Since the referenced letter, [REDACTED] technical personnel with guidance from your technical representative have performed another thorough review of the Panoramic Stereoviewer. The result of this review and the proposed tasks to complete the program are discussed in enclosure "A" to this letter.

DESCRIPTION OF PROPOSED MODIFICATIONS TO THE PANORAMIC STEREOVIEWERGENERAL

FIGURE 1

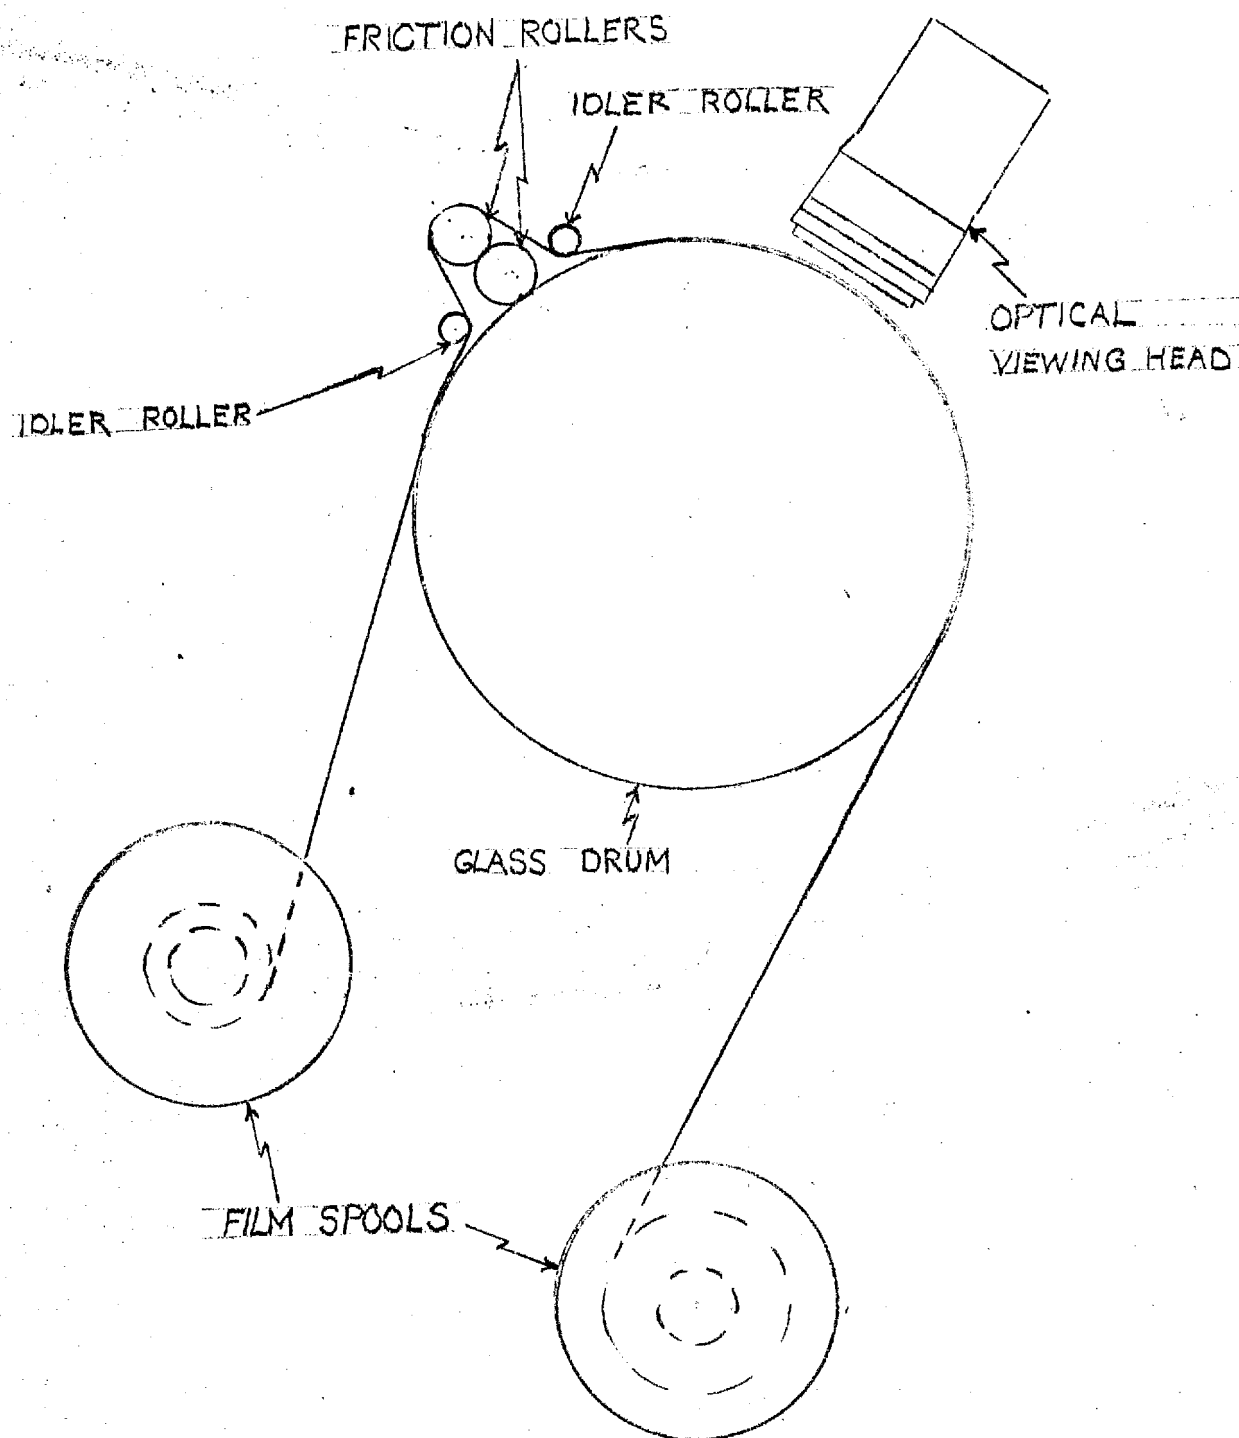
The drive modification will be essentially a mechanical modification. As illustrated in Figure #1, a pair of rubber coated friction rollers and two idler rollers will be added to the film loop over the glass drum stages. One of the friction rollers will be in contact with the drum and with the second friction roller. The second friction roller will make contact with the film. The idler rollers will be positioned on either side of the friction rollers to maintain the maximum amount of wrap-around surface contact between the film and

and second friction roller. All rollers will rotate with a minimum of frictional drag on roller bearing supported shafts.

In "X" motor drive the film is tensioned over the drum and the upper (second) friction roller. It is driven by torque motors which are gear connected to the film spools - the same system as on the present instrument except for the addition of the friction rollers. The coefficient of friction between the upper friction roller and the film, drives the roller at the same surface velocity as the film. The roller in turn drives the other friction roller and drum at the same surface velocity as the film. Though the film in contact with the drum will assist in driving the drum as on the present system, the prime driving force for the drums will be the friction rollers.

To drive the film manually in "X" the present handwheels on the center column will be used. However, instead of driving the drum through a flexible drive to a large gear on the drum, the flexible drive will be gear connected to the upper friction roller which engages the film. The friction roller will in turn drive the film and the surface of the drum simultaneously at the same speed. The drive will be engaged by a magnetic clutch which will automatically disengage when driving the film in the motor mode. Tensioning the film will be through torque motors in both the manual and motor modes, as on the present instrument.
